NSW PLANNING ASSESSMENT COMMISSION

The Proposed Riverside Development at Tea Gardens
Concept Plan and Project Applications
Review Report

July 2009

Figure 2 Potential Developable Area with Constraints

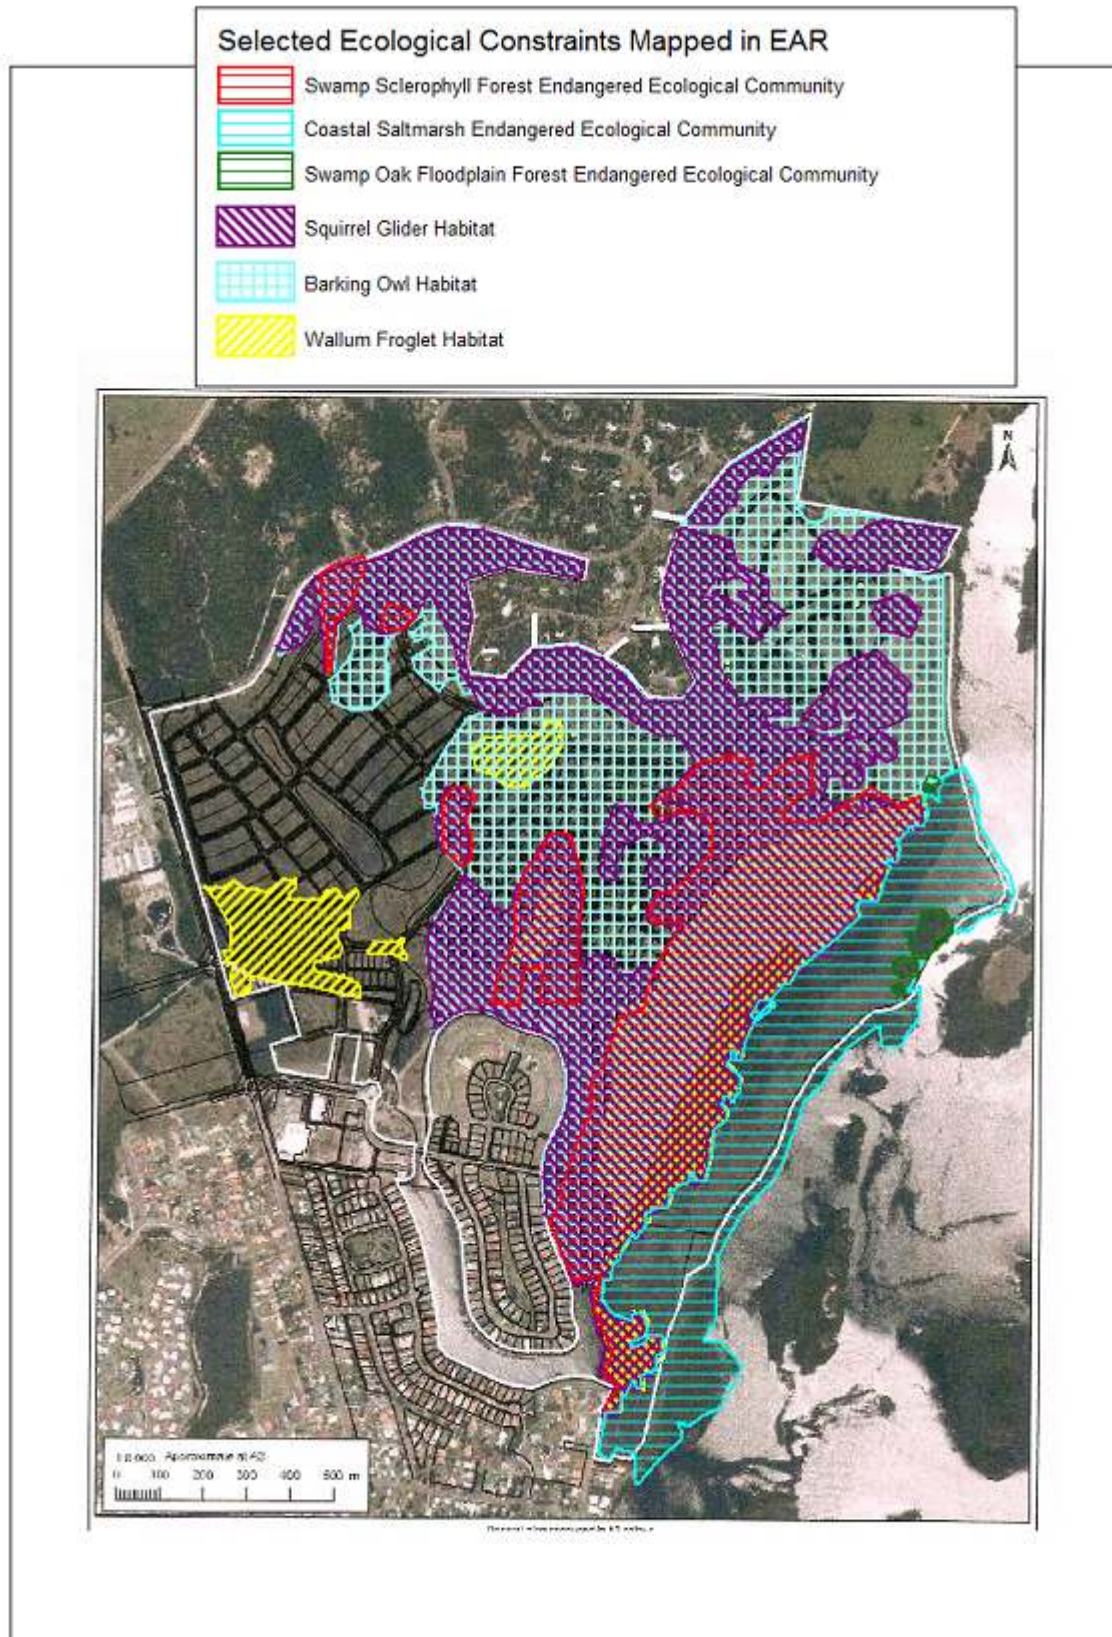
The majority view is that the second option is more likely to lead to an optimal outcome for the site provided the guidance given becomes the basis for a revised proposal. Whilst there are some obvious risks in giving firm guidance on information that all members of the Commission view as inadequate, these risks are mitigated by requiring the Proponent to establish an adequate information base as part of any revised proposal and then requiring appropriate protection or offsets for any significant habitats identified in the area marked as developable in Figure 2 (page 54). It should also be noted that the currently identified areas of significant habitat are predominantly located in the eastern portion of the site which is marked as non-developable in Figure 2.

The main reasons the majority report has opted for the configuration in Figure 2 are:

Figure 2 (page 54) provides general guidance as to the areas that the majority of Commission considers should not be subject to development and those it considers may be able to be developed subject to satisfactory arrangements for dealing with any endangered ecological communities or areas of threatened species habitat present. Figure 3 (page 55) shows the main known ecological constraints on the site. Figure 2 is provided with the following caveats:

The reasons the majority of the Commission has opted for the configuration proposed in Figure 2 are:
